To: Hunter and Central Coast Regional Planning Panel  
From: Emma Brown, Senior Development Planner  
Salli Pendergast, Section Manager  
Subject: E-determination – DA/2371/2023 12-14 Jennings Road, Wyong  
Date: 8 October 2025

This memo is to provide information to the Regional Planning Panel as part of their consideration of the DA prior to the e-determination meeting of 9 October 2025:

Figure 1 Aerial of site locality and proximity to shops, transport and other facilities

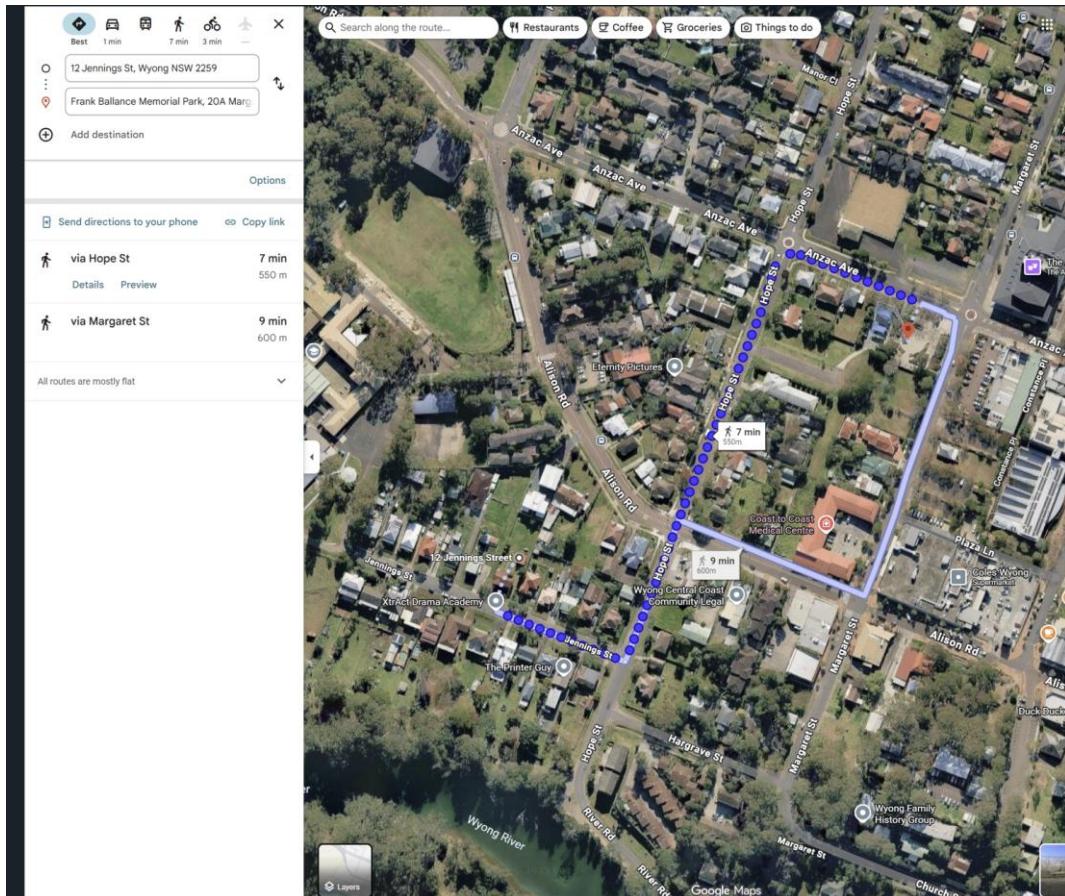
The Panel requested a map to show access to shops, transport, other facilities and communal public open space.

Figure 1 on page 5 of 28 of the epm projects SEE Addendum, dated 22 August 2025 includes an image of amenities within proximity to the subject site.
